MOTORCYCLE 3/3/2017 M2017-001R

SAFETY RECALL

CERTAIN 2015~2016 YZF-R3 MODELS FACTORY MODIFICATION CAMPAIGN – Fuel Tank Fitting Bracket and Main Switch Subassembly

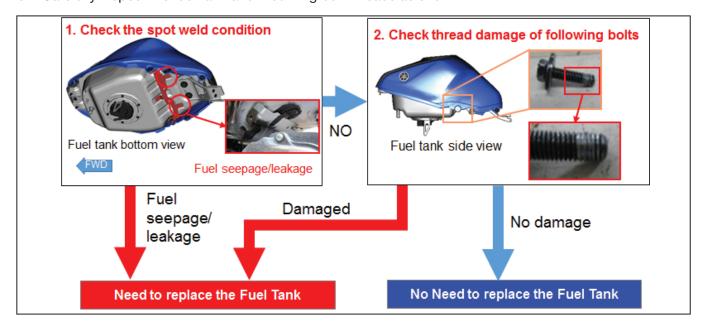
4. Loosen fuel tank fitting bracket bolts (A), then loosen fuel tank rear bracket bolts (B). Remove fuel tank (C) and unplug the breather hose, overflow hose, fuel hose, fuel pump coupler, and main switch coupler.

5. Carefully inspect the fuel tank and mounting bolt threads as shown.

If the fuel tank must be replaced, submit a Warranty / Y.E.S. Authorization on YDS. When approved, order and install the new fuel tank before continuing. Otherwise, continue with step 6.

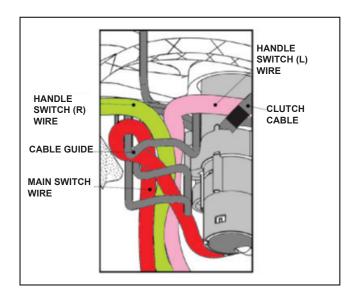
Reinstall the cable guide bolts, upper triple clamp, brake hose joint holder, and handlebars.
 Torque to proper specifications per the Service Manual.

Confirm that cables and wires are properly routed in the cable guide.

PARTS INFORMATION

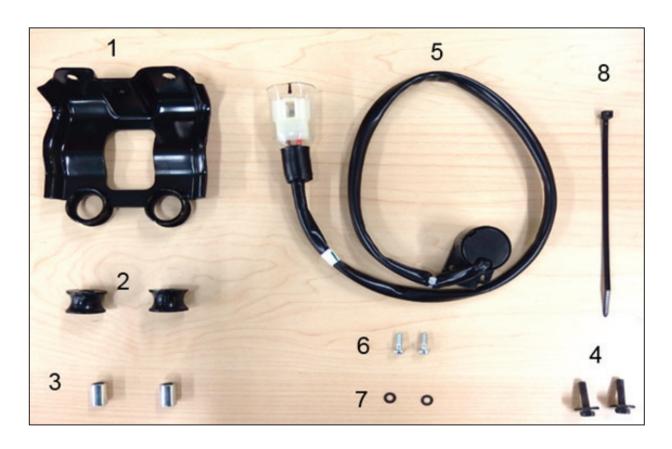
Part Number	Part Name	Qty.	Application	Dealer Cost
90891-20291-00*	Main Switch and Fuel Tank Bracket Kit	1	YZFR3	\$5.99
	Contains:			
	(1) Bracket, Tank Fitting Fr.	1		
	(2) Grommet	2		
	(3) Collar	2		
	(4) Bolt. Hex. W/Washer	2		
	(5) Sub-Switch Assembly	1		
	(6) Screw, Special	2		
	(7) Washer, Special	2		
	(8) Clamp	1
